UNITED STATES PATENT AND TRADEMARK OFFICE

10/581,314

Office Action Summary	Application No. 10/581,314	Applicant(s) LIMMA ET AL.	
	Examiner Robert F. Long	Art Unit 3764

DETAILED ACTION

Fig. 3

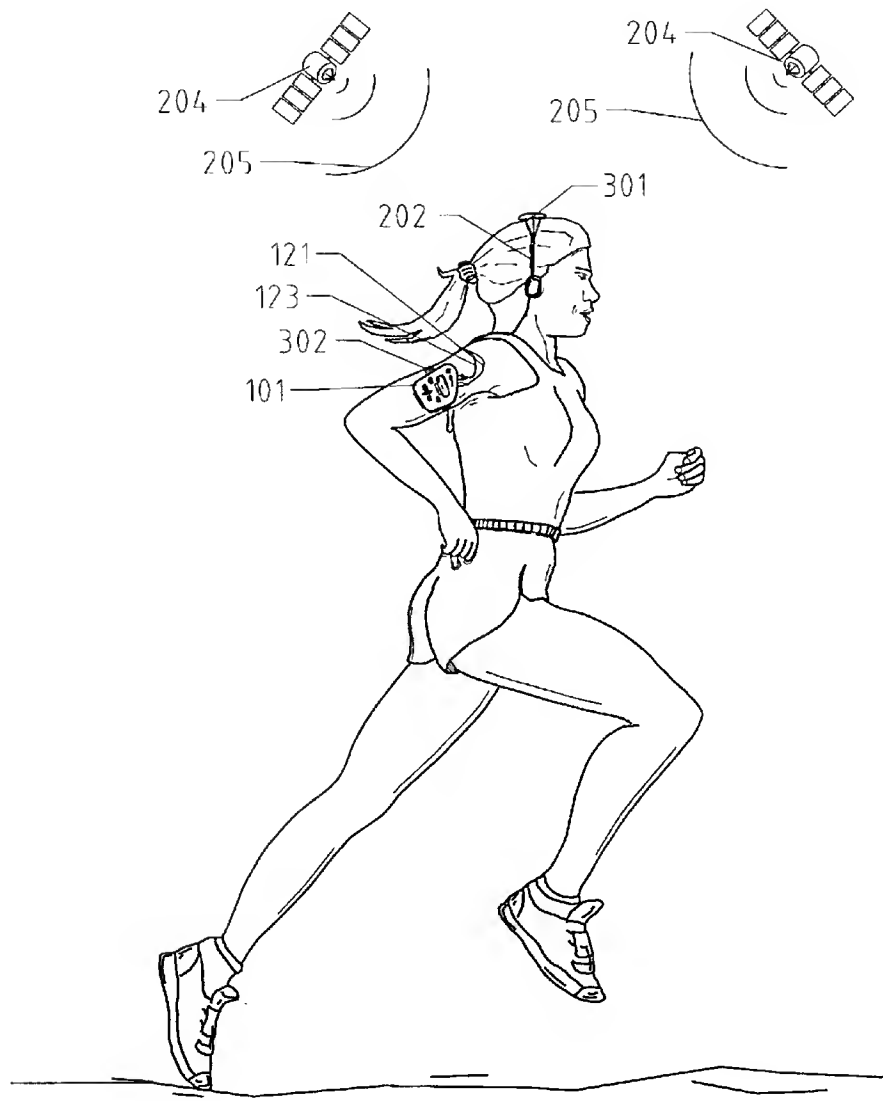
Regarding claims 1-26, Root et al. discloses a measuring device (feedback device 101 figure 6) and system (feedback device 101, headphones 202, and antenna 301, with satellite 204 to form communication). See figure 3 below -

Fig. 6

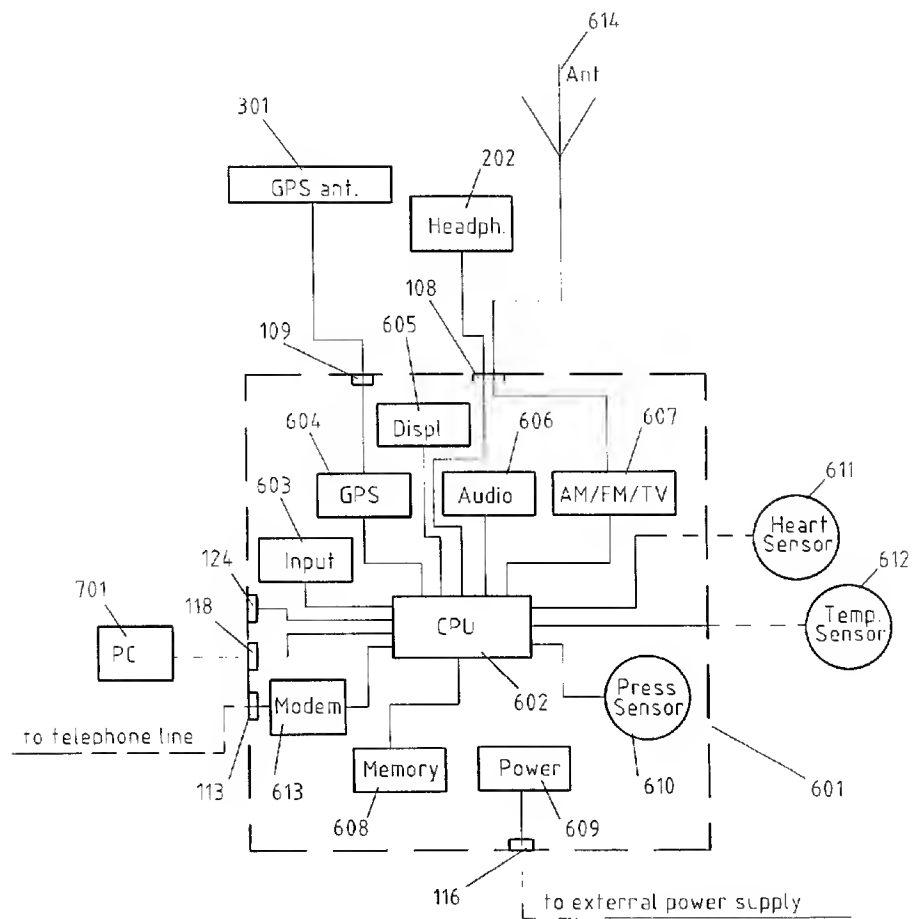
Root also discloses a method of transmitting via a transmitter (modem 613, figure 6) and providing at least one individual with feedback based on a measured sports activity (running figures 2-3) information, wherein the system and method comprises: a measurement device (feedback device 101 having measurement barometric sensor 610, figure 6) comprising a first processor (CPU 602, figure 6), a plurality of measuring elements (sensors 610-612, figure 6) configured to measure a plurality of quantities relating to a sports activity, a first memory (memory 608, figure 6) configured to store measurement data provided by the measuring elements comprising a GPS receiver (604, figure 6), barometric sensor (610), heart sensor (611, figure 6), and a thermometer, (body temperature sensor 612, figure 6), and a transmitter (modem 613, figure 6) configured to transmit sports activity (running figures 2-3) information during the sports activity (running figures 2-3) to at least one a receiving device via a local communication link according to a communication protocol, (feedback transfer column 8, lines 59-67); and the receiving device (GPS receiver module 604, figure 6) comprising a receiver (antenna 301, figure 6), configured to receive a transmission from the measurement device during the sports activity (running figures 2-3) via a local communication link, wherein the transmission includes sports activity (running figures 2-3) information measured with the measurement device (feedback device 101, figure 6), a second memory (built in memory of GPS receiver module 604, figure 6) configured to store at least one definition based on which a predefined set of pieces of sports activity (running figures 2-3) information is selected from the received sports activity (running figures 2-3) information, and a second processor (built in processor of GPS receiver

module 604, figure 6) configured to select the predefined set of pieces of sports activity (running figures 2-3) information from the received sports activity (running figures 2-3) information based on the at least one definition, which is defined based on the sport in question, stored on the second memory (built in memory of GPS receiver module 604, figure 6); and at least one feedback device (feedback device 101, figure 6) configured to provide the at least one individual with feedback on a user interface display based on the selected sports activity (running figures 2-3) information, (column 4, lines 4-67, column 5, lines 1-67, figures 1-12). See figure 6 below for electrical schematic of the feedback device —

Fig. 10

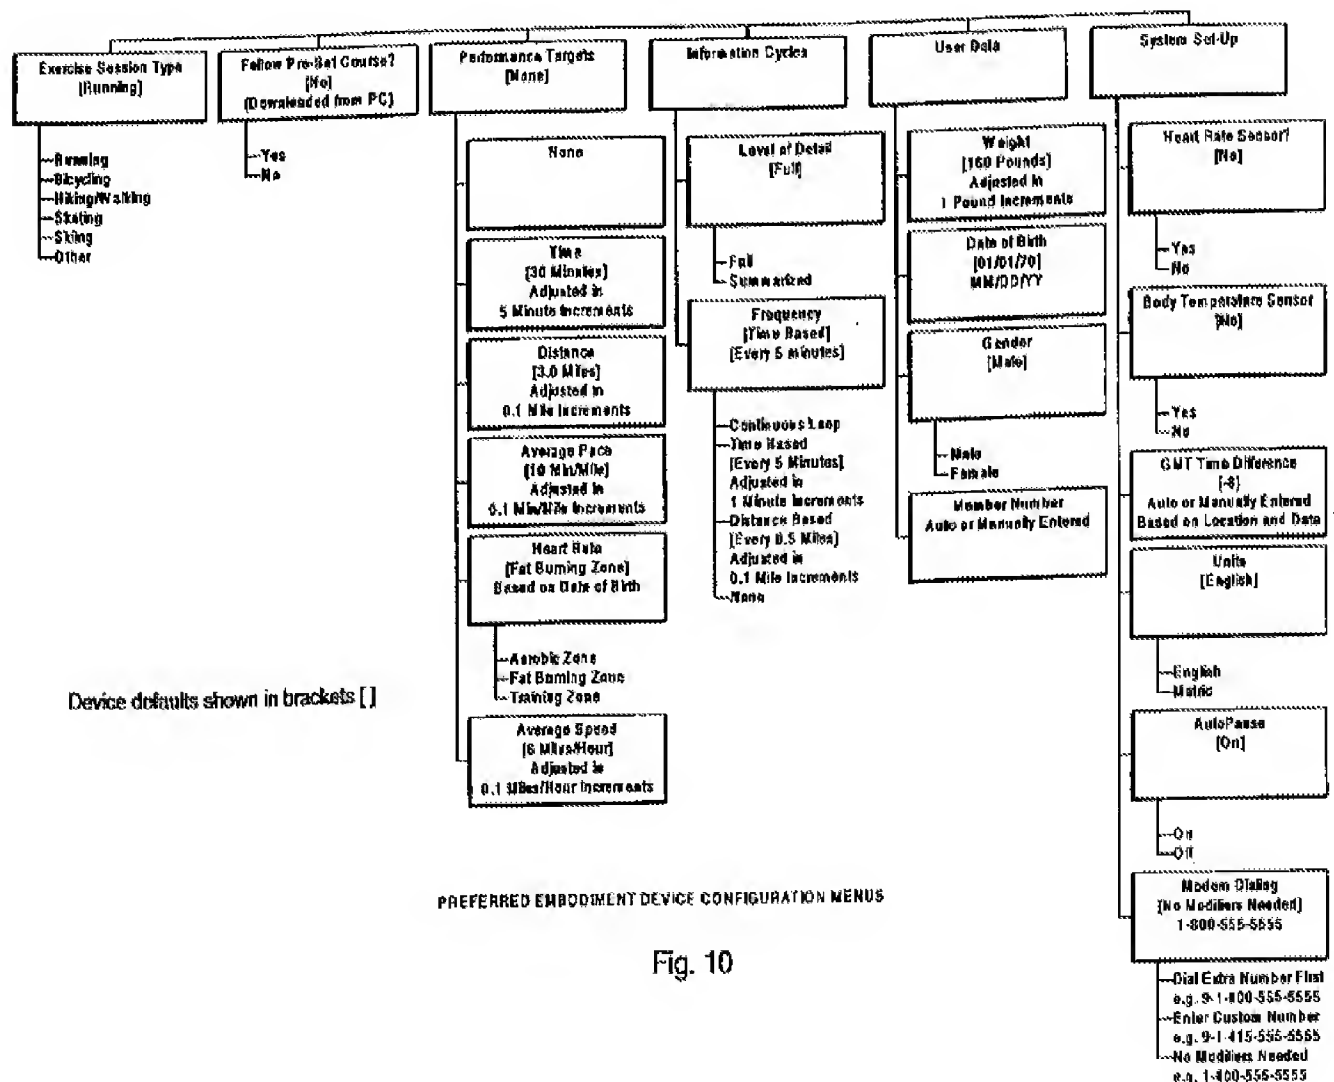
Root et al. also discloses the system and method comprises the feedback device (101, figure 6) a display having graphical features, geographic position on display 112, column 4, lines 10-15), voice signals (audio module 606, column 35-64), ear piece, (headphones figures 2-5), and a speaker (column 11, lines 1-5). Root et al. also discloses a menu and selection choices for the desired activity, (column 6, lines 42-49, figure 10). See figure 10 below for menu selection and activity settings –
